CITY PLAN COMMISSION

FILE NUMBER: Z212-271(JA)-R **DATE FILED:** May 25, 2022
LOCATION: Northeast corner of Linfield Road and Bonnie View Road
COUNCIL DISTRICT: 4
SIZE OF REQUEST: Approx. 10.19 acres **CENSUS TRACT:** 48113008703

REQUEST: An application for a Specific Use Permit for a public school other than an open-enrollment charter school on property zoned an R-5(A) Single Family District.

SUMMARY: The purpose of the request is to allow for the construction of a new public school to replace the existing public school. [W.W. Bushman Elementary School]

PROPOSED SUP SITE PLAN *[Revisions Pending]*

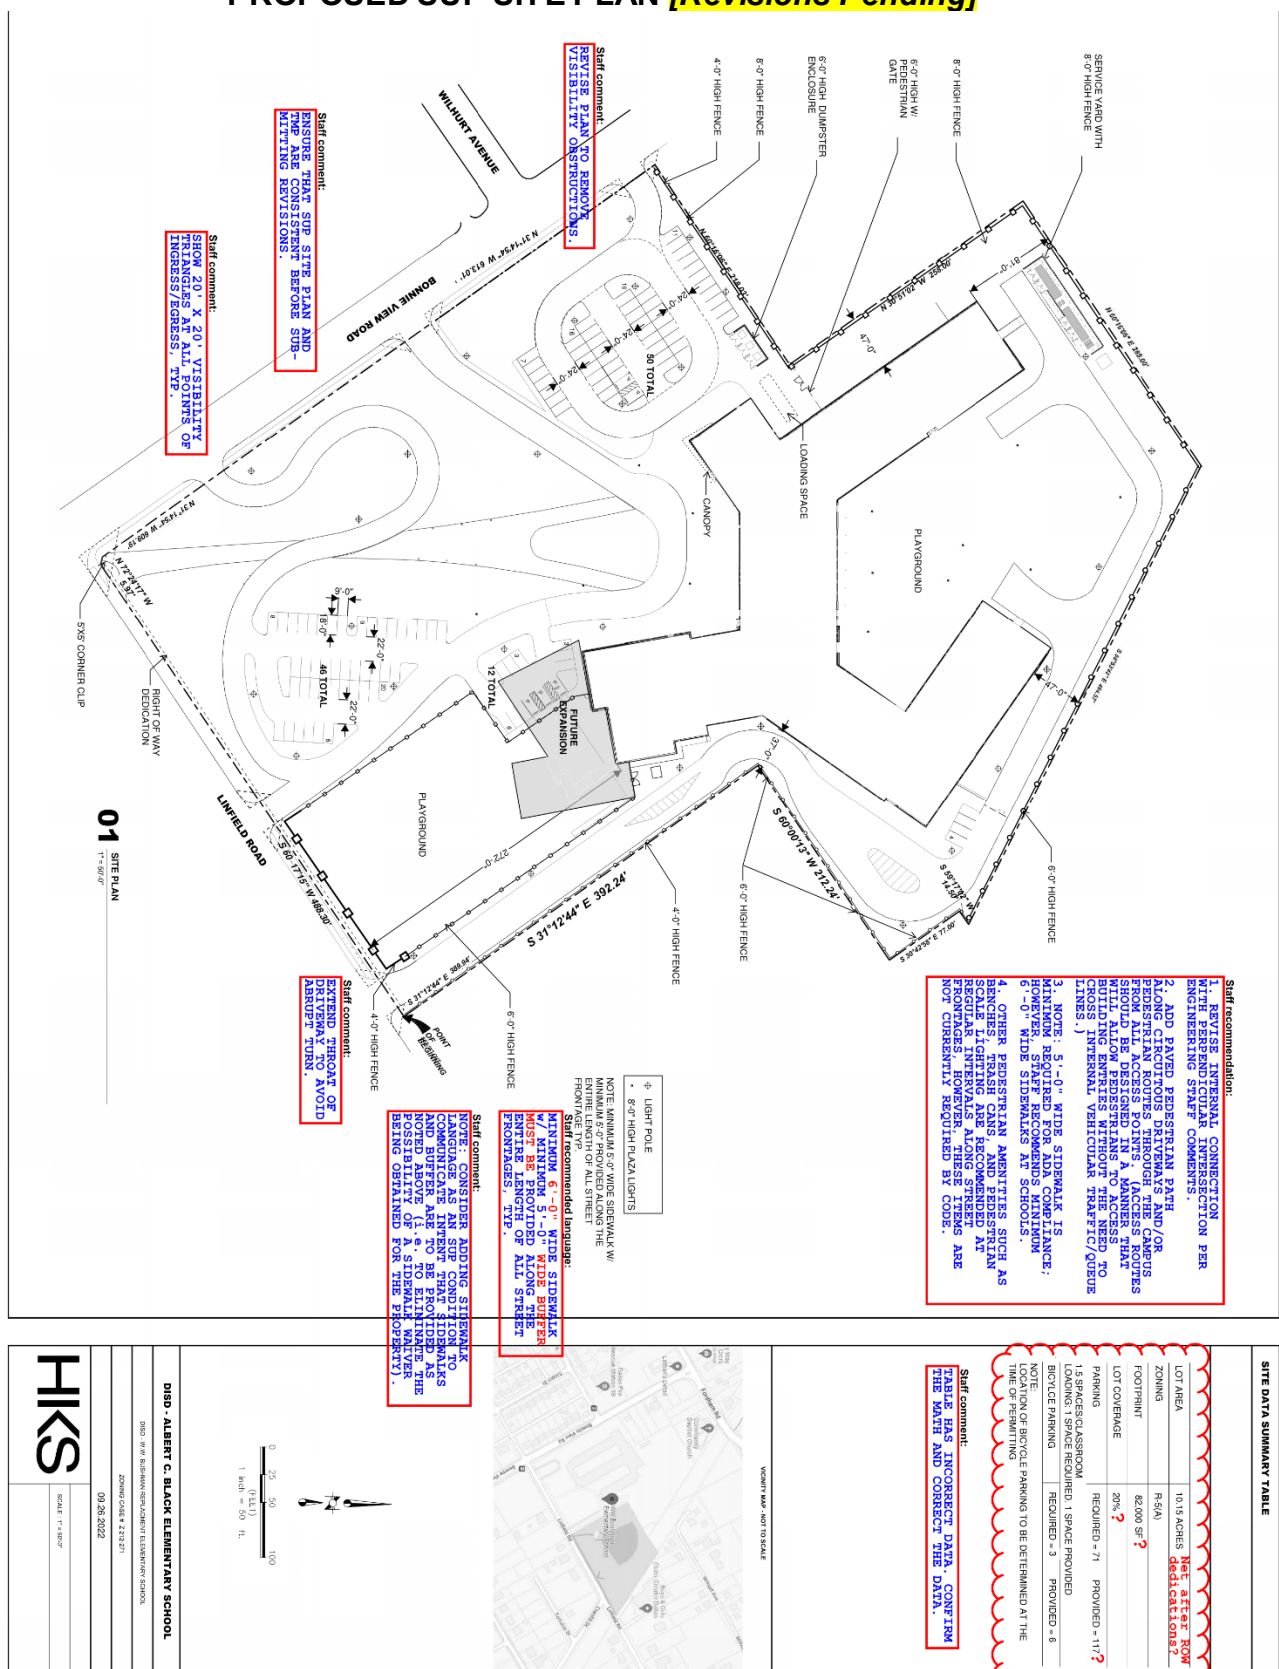
- Revise internal connection with perpendicular intersection.
- Add paved pedestrian path along circuitous driveways and/or pedestrian routes through the campus from all access points.
- Extend throat of driveway on Linfield to avoid abrupt turn since design does not physically discourage wrong way turns.
- Minimum 5'-0" wide sidewalk is required for ADA compliance; however, staff recommends minimum 6'-0" wide sidewalks at schools. The Street Design Manual indicates a minimum 5'-0" wide buffer is required between back of curb and leading edge of sidewalk.

The proposed use is compatible with the surrounding neighborhood and is consistent with the existing zoning and with the general provisions for a Specific Use Permit. However, staff notes that a revised site plan and a revised traffic management plan (TMP) are needed for the proposed development to fully comply with the ordinances, rules, and regulations of the City of Dallas. Additional staff recommended changes to the site design and TMP support and encourage safe pedestrian routes to and from the school site. Detailed staff comments are noted on the proposed SUP site plan included later in the case report.

1 Traffic Management Plan
Not to Scale

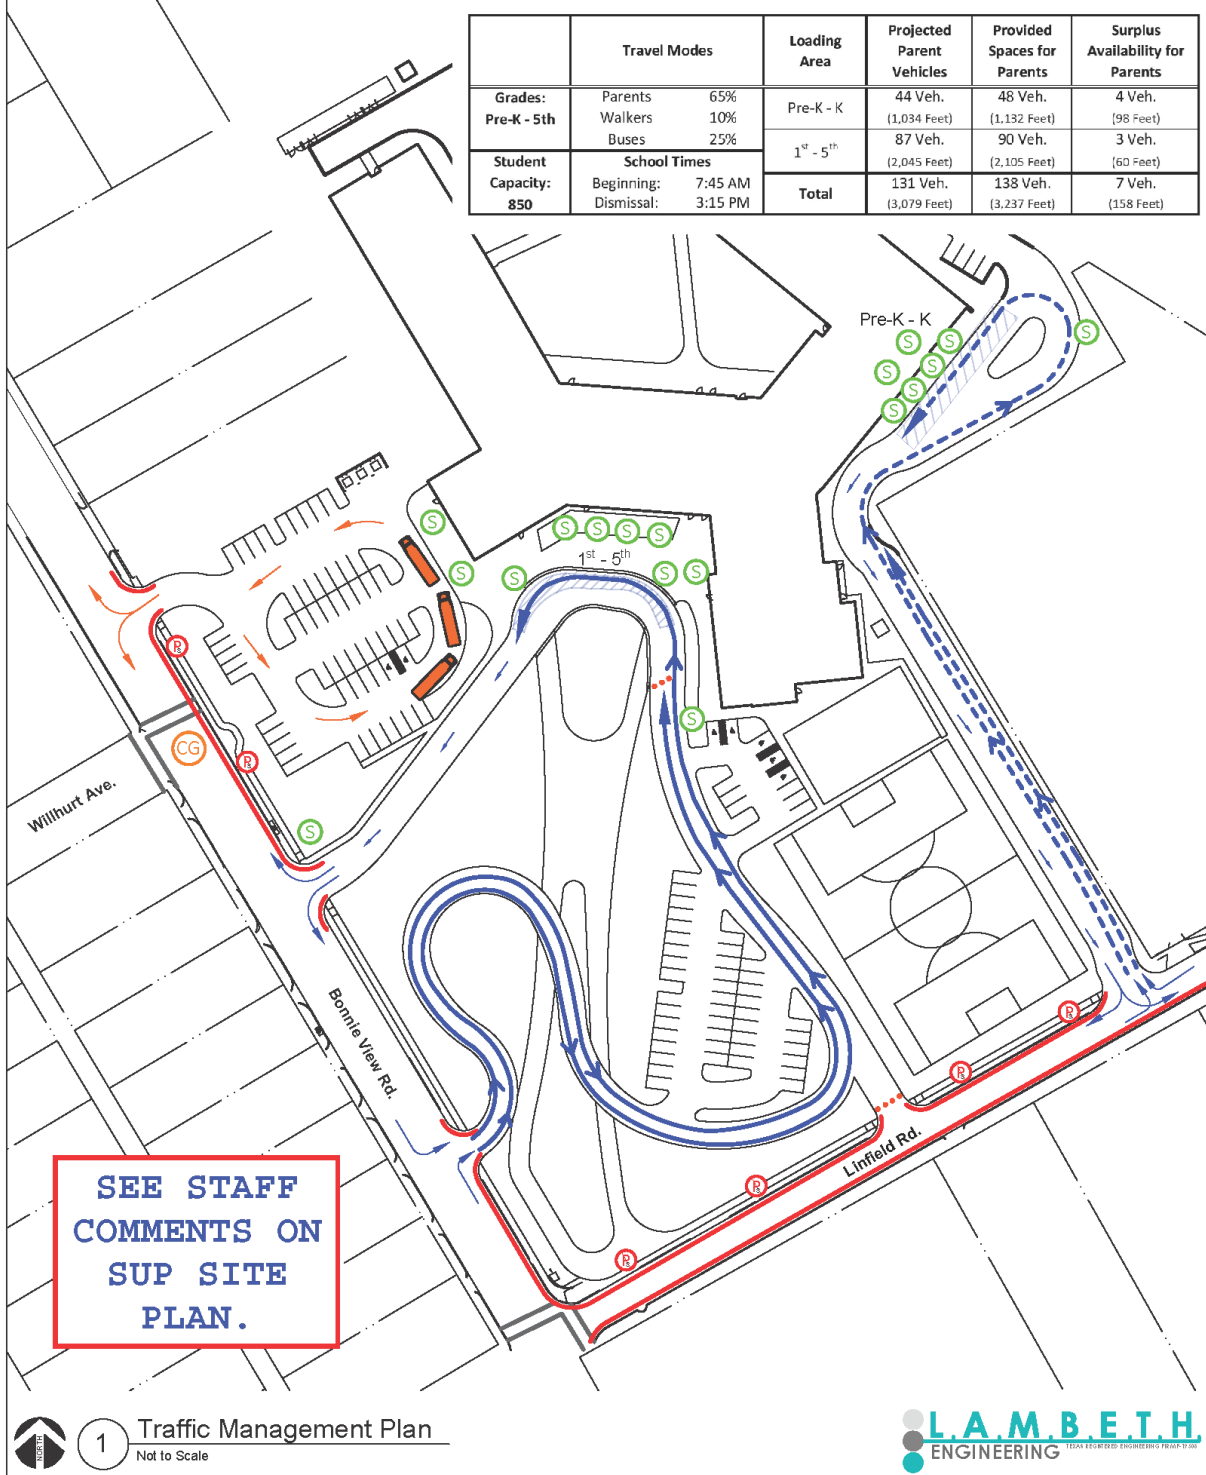
**SEE STAFF
COMMENTS ON
SUP SITE
PLAN.**

PROPOSED TMP [Revised; Further Revisions Pending.]

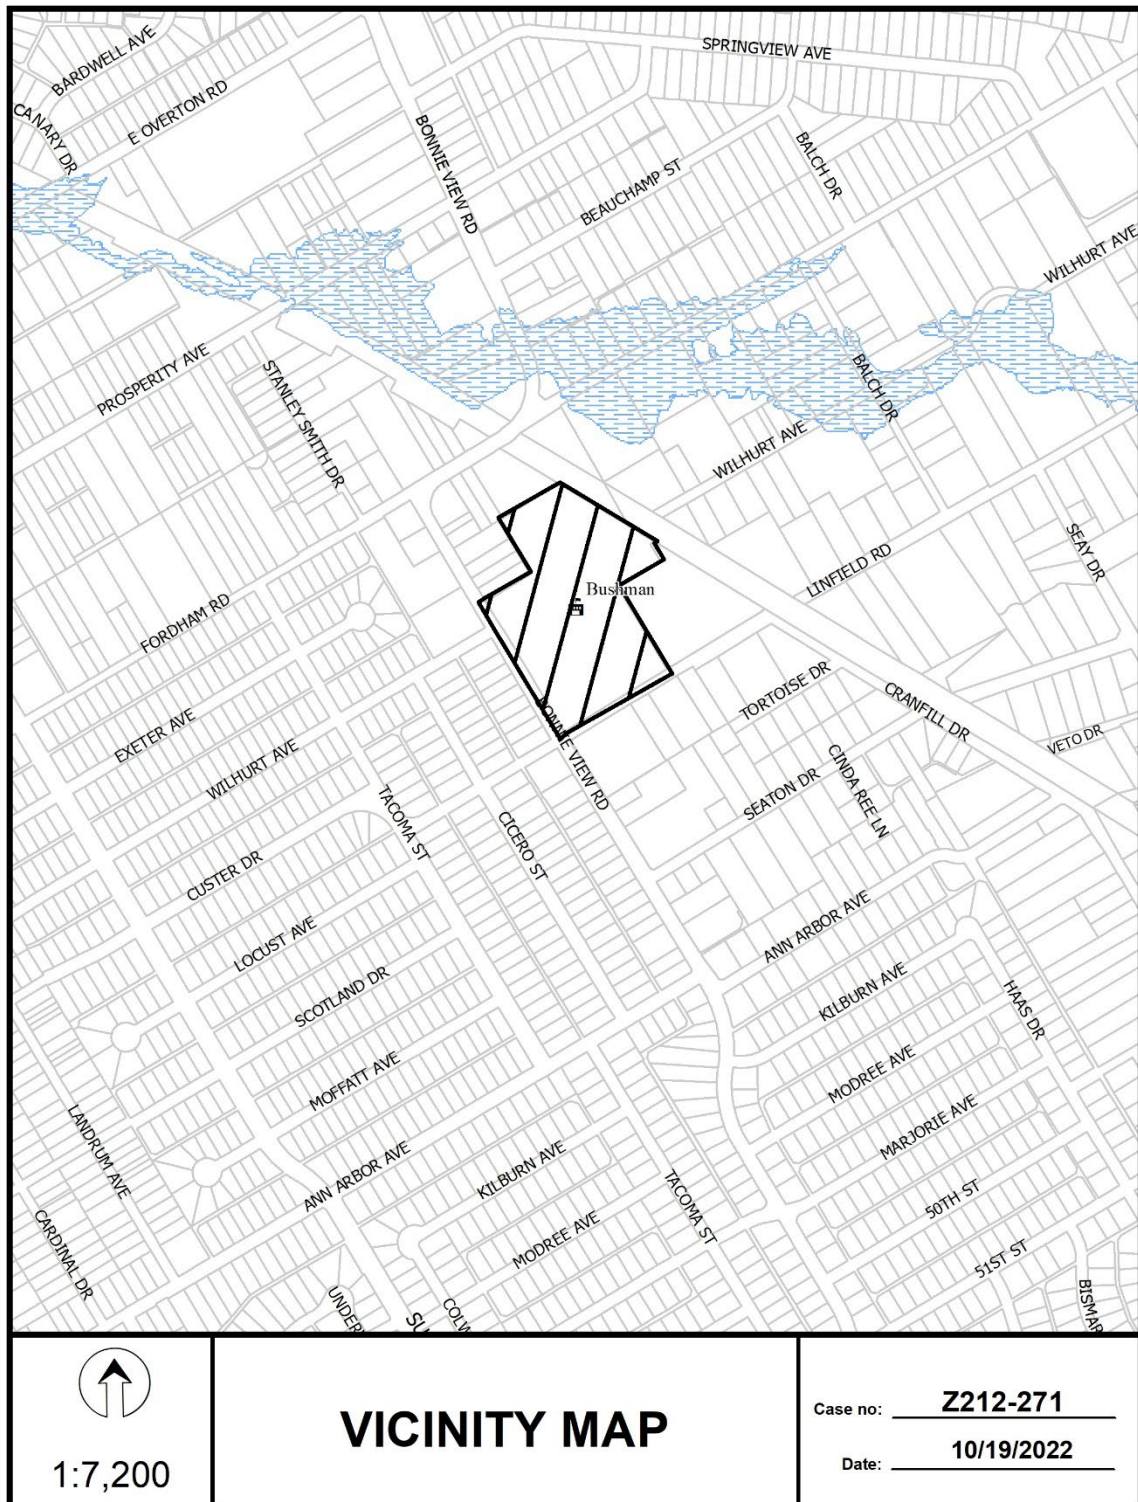
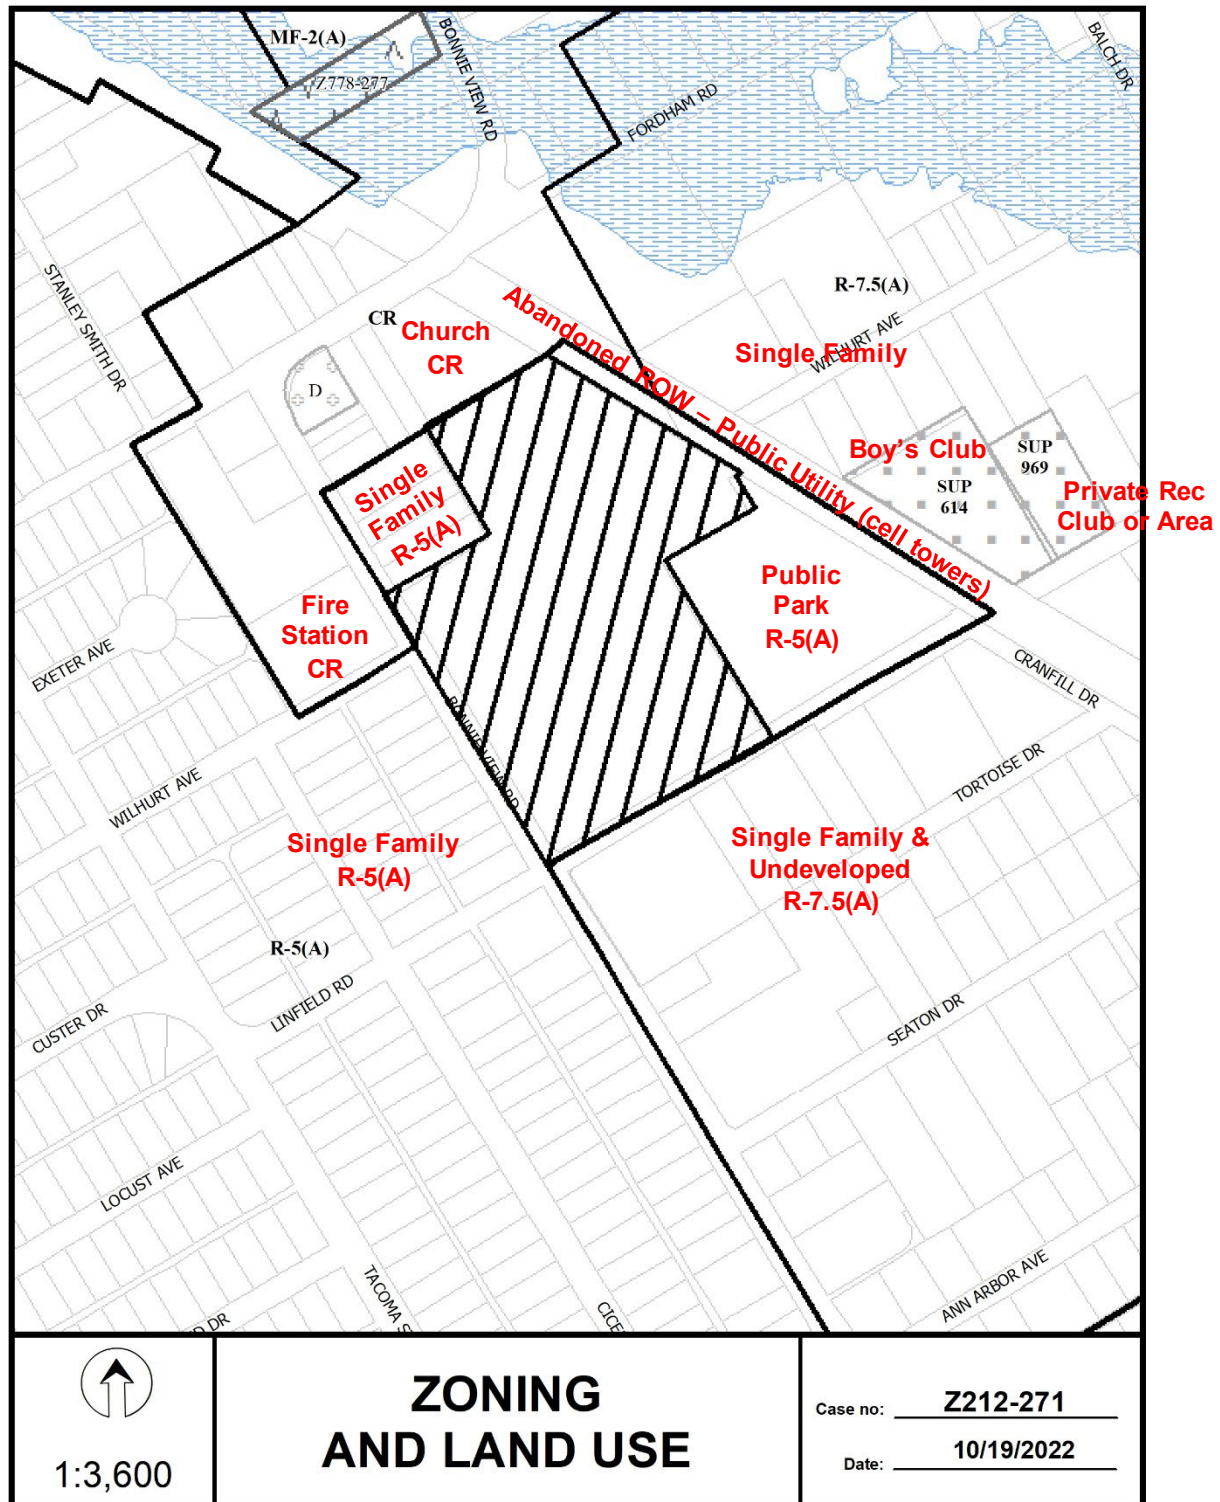
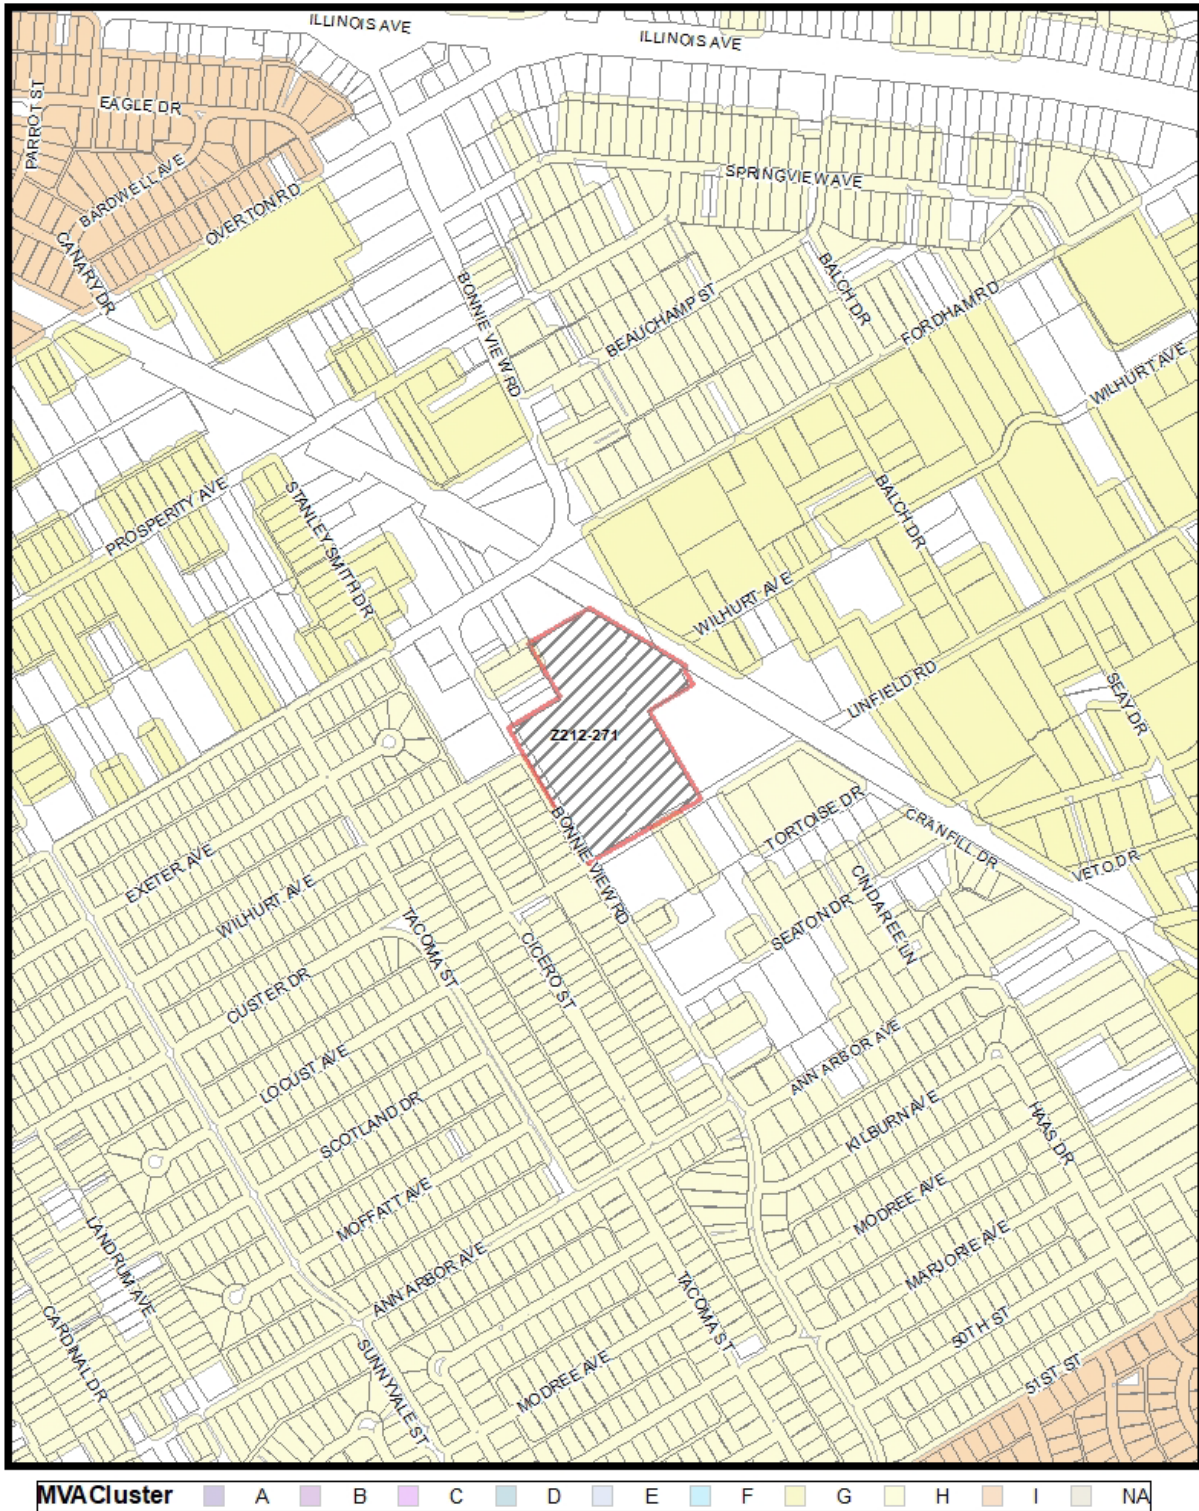
Staff finds that the revised TMP proposal better supports pedestrian access to/from the site and circulation within the site to building entries; however, it is recommended that access routes be designed in a manner that will allow pedestrians to access building entries without the need to cross internal vehicular traffic/queue lines. Where pedestrian pathways do intersect with queue lines, staff recommends that these intersections occur at 90 degrees. Further, staff has requested that the applicant explore the possibility of removing the southernmost ingress-only point on Bonnie View Road and reconfiguring the circuitous route to provide a combined ingress/egress point along Bonnie View Road.
